**Defects Review Bridlewood Pointe of View Project Last Update June 18/08**

This Update report contains a review of resident reported defects in the common areas of the Bridlewood Pointe of View project during the initial one year warranty period. All defects were reported to the developer Pointe of View on the residents' behalf by the board of directors for this complex within this one year period.

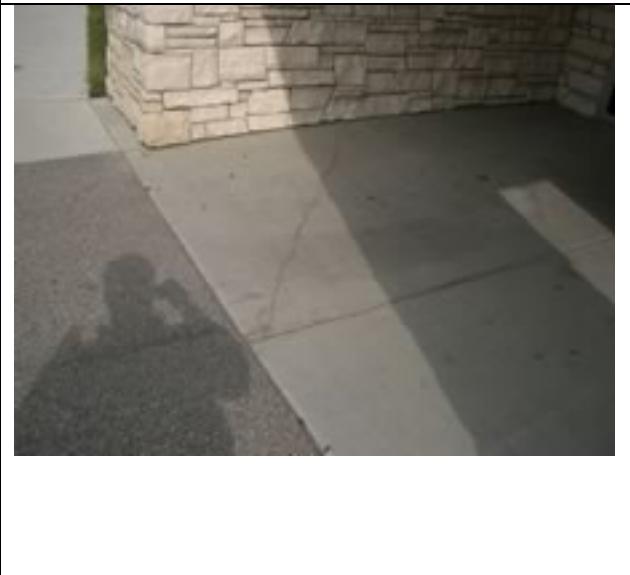
Location	Defect	Photographs
1000-P Item#11	<p>Leakage of water through parkade walls in Building 1000 resulted in flooded parkade during first few months of occupancy. Promised repairs after major flood have not been undertaken. Concrete bib adjoining top of wall not sealed correctly.</p> <p>POV to Fix</p> <p>Update 05/28/2008 Not fixed. We experienced again this spring severe leakage through this wall.</p>

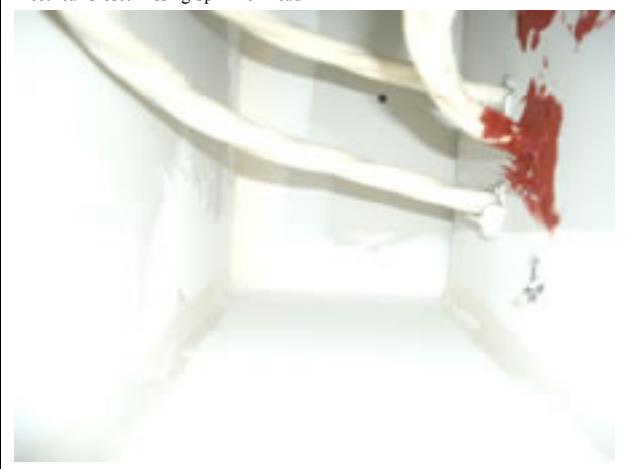
Location	Defect	Photographs
1000-P Item#12	<p>Serious water leakage on wall in SW Corner behind Air Exchanger Unit (MUA) in Parkade. Resulting standing water is damaging drywall in storage unit wall. This leak occurs every rain and was supposed to have been fixed a year ago, clearly it was not.</p> <p><b>POV to Fix</b></p> <p>Update 05/28/2008 Not fixed. We experienced again this spring severe leakage through this wall.</p>	
1000-P Item#17	<p>Fire rated protection missing from some piping penetrations in 1000 between the parkade and suites above. Fire rated compounds and Fire related sleeves to provide 1 hour fire separation. <b>This is a serious code violation.</b></p> <p><b>Eng. Report issue FLS6 section 11.5.3</b></p> <p><b>This concern also to the mechanical rooms in all 3 buildings as identified in the Eng. Report. See the report for more information.</b></p> <p><b>O-Ring – See comment POV response in Eng. Report.</b></p>

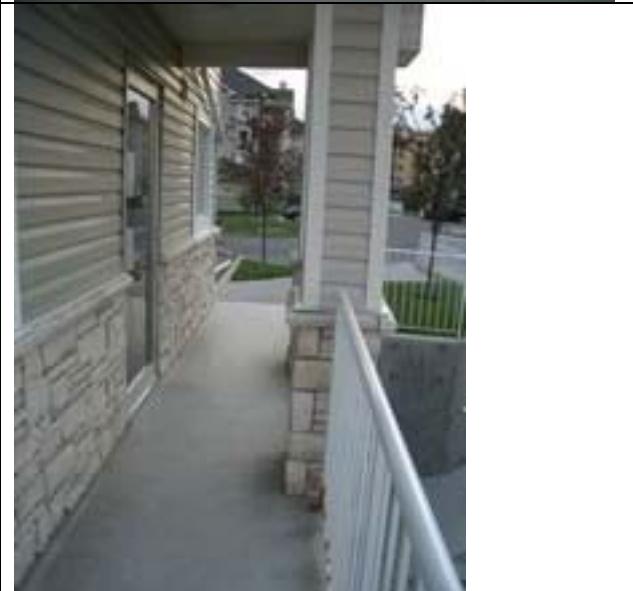
Location	Defect	Photographs
1000-P Item#71	<p>Parkade exhaust fans are missing outlet hoods are result water leakage is occurring in Parkade.</p> <p><b>Eng Report Item #M17</b></p> <p>Update 05/28/2008</p> <p>Not fixed. We experienced again this spring leakage through these units.</p>	<p>1000 Parkade Missing Hoods</p>  <p>1000 Parkade Leakage due to missing hoods</p>  <p>3000 Parkade Proper Hoods in Place (no leaks here)</p>
